# Development Services Reports

**Committee Consideration – 11 October 2011**  
**Council Resolution – 25 October 2011**

<b>D58.11</b>	<b>No.60 (Lot 11541 and Reserve 33986) Lemnos Street, Shenton Park – Proposed Reconfiguration to Existing Waste Transfer Station</b>
---------------	--

<b>D59.11</b>	<b>No.7 (Lot No.112) Riverview Court Dalkeith – Proposed Four Storey Dwelling, front fence and Swimming Pool</b>
---------------	--

## D58.11 – Attachment 6 Elevation Plan

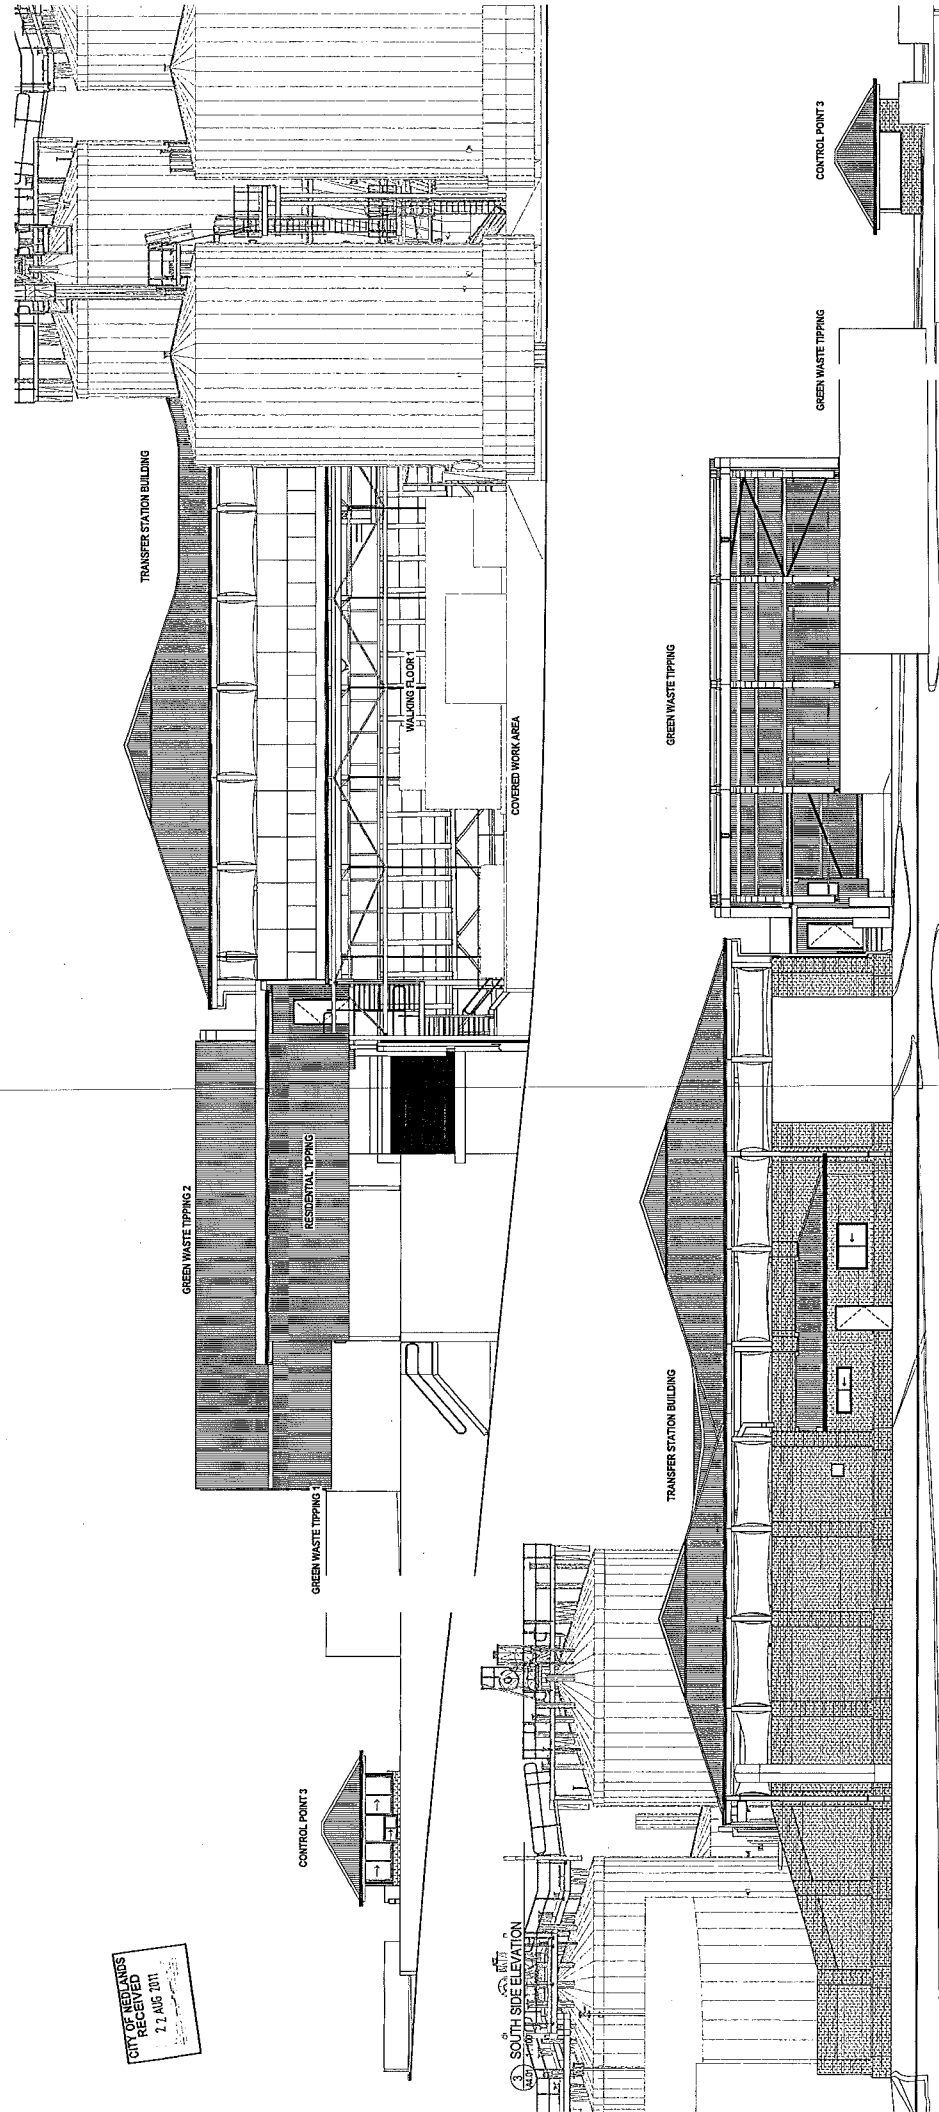
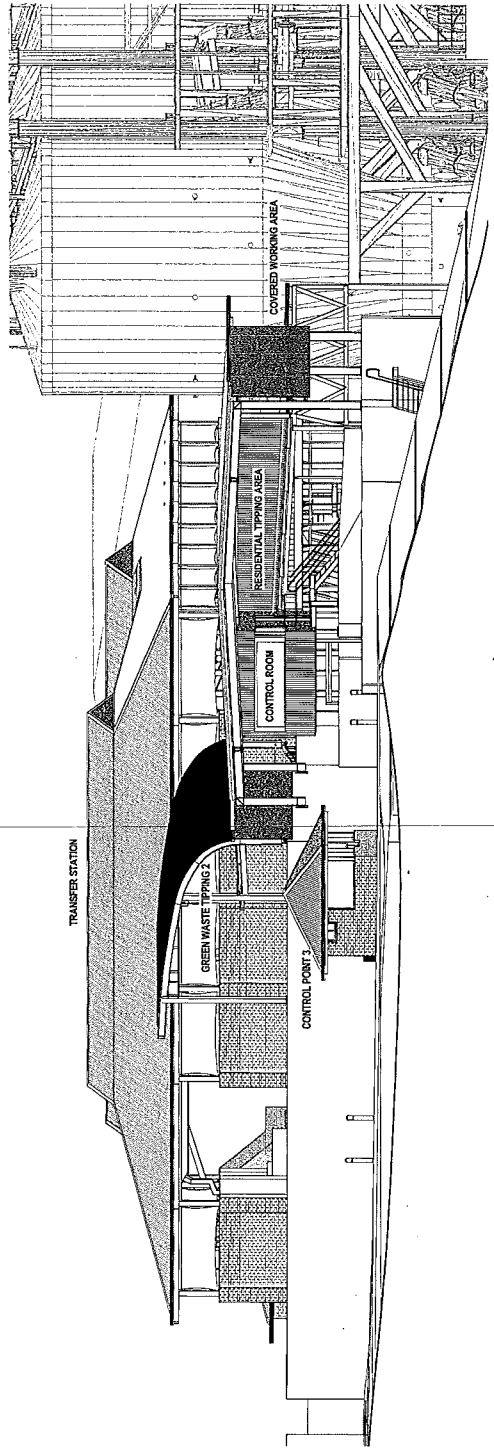
A second greenwaste tipping area is located near the centre of the site and the proposed walking floor. This greenwaste area is to be setback 10 m from the site boundary facing Lemnos Street and 41 m from the site boundary on Brockway Road. The residential tipping area is located near the centre of the site and the proposed walking floor. This area is setback approximately 48 m from the site boundary on Brockway Road. These areas are covered by awnings (refer to attachment 6).

D59.11 – Attachment 6  
Upper Floor Plan

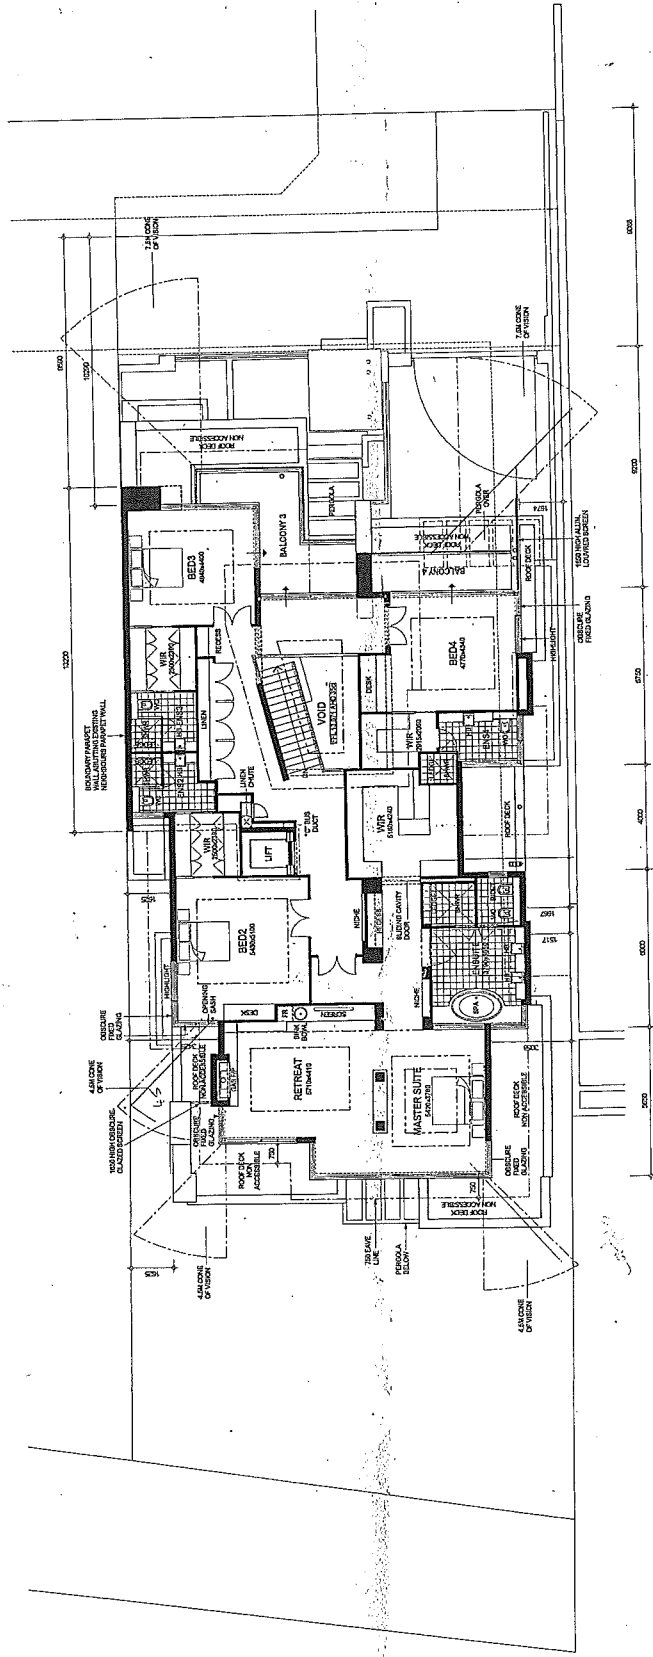
- 1. prior to the issue of a building licence, the plans shall be amended to show the proposed screen located on the southern side of balcony 4 shall be increased in length by 1.2 m to protrude a total of 4.7 m, in order to comply with Clause 6.9.1 of the Residential Design Codes (RCodes) (as marked in red on the approved plans);**

Officer comment	technical	<p>The proposed cone of vision from the upper balcony 4 does not comply with the acceptable development criteria of the RCodes.</p> <p>It is also considered that the overlooking from balcony 4 does not meet the performance criteria of the RCodes as it has views into the outdoor courtyard on the neighbouring property and does not fully protect their privacy.</p> <p>It is therefore recommended a condition be placed on the approval that the privacy screen shown on the plans be increased in length to remove any non-compliance with the privacy provisions of the RCodes.</p>
-----------------	-----------	--

It is therefore recommended Council approve the application with a condition that the existing screening along the southern side of balcony 4 is increased in length to remove any overlooking.

D59.11 – Attachment 9  
Overshadowing Diagram

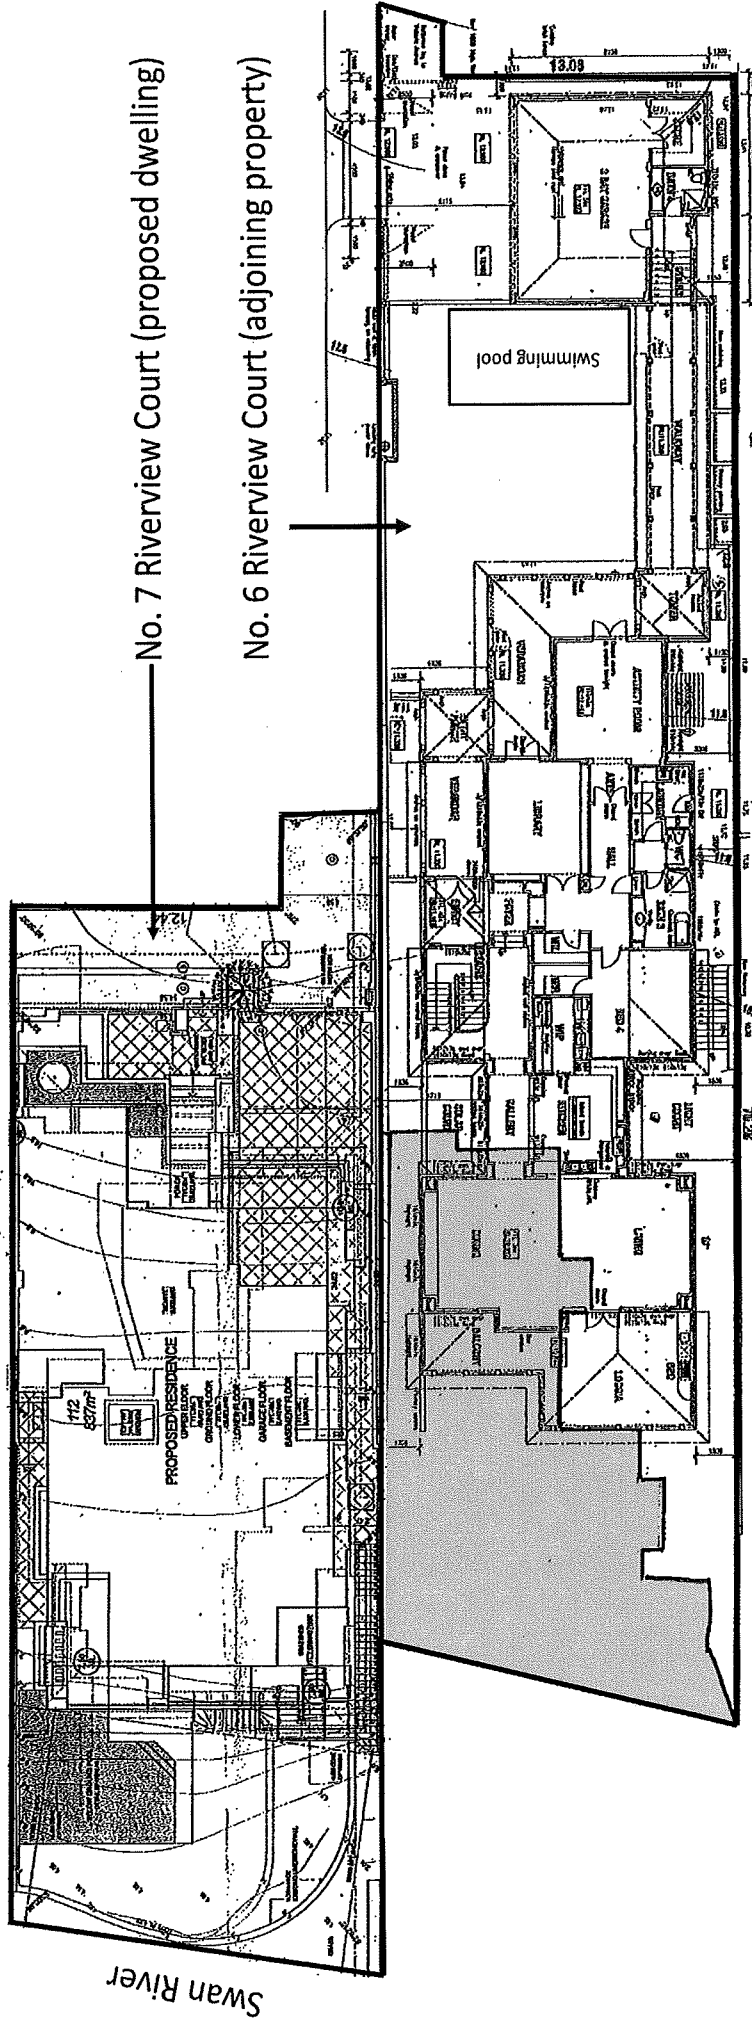
<p>Acknowledge that the overshadowing meets the acceptable development criteria of the RCodes, however consideration should be given to the fact that the boundaries of both properties do not align which results in the major living areas of the property being overshadowed.</p>	<p>It is noted that the location of the proposed dwelling is directly adjacent to a number of the main indoor habitable living areas on the southern property resulting in partial overshadowing.</p> <p>However as the proposed lot is considerably smaller in size than the property to the south there is limited area to build on the site and it would be impossible to avoid some overshadowing of the southern property, especially on the western portion of this property (as indicated in attachments 9 &amp; 10).</p> <p>Furthermore it is noted that under the RCodes Council is required to approve applications where the acceptable development criteria are met and the overshadowing complies.</p>

The proposed dwelling casts a shadow at midday on 21 June with a maximum area of 19 % of the neighbouring property.

In relation to the RCode overshadowing requirement of 25 % the application complies with the acceptable development criteria with proposed overshadowing of 19 %.
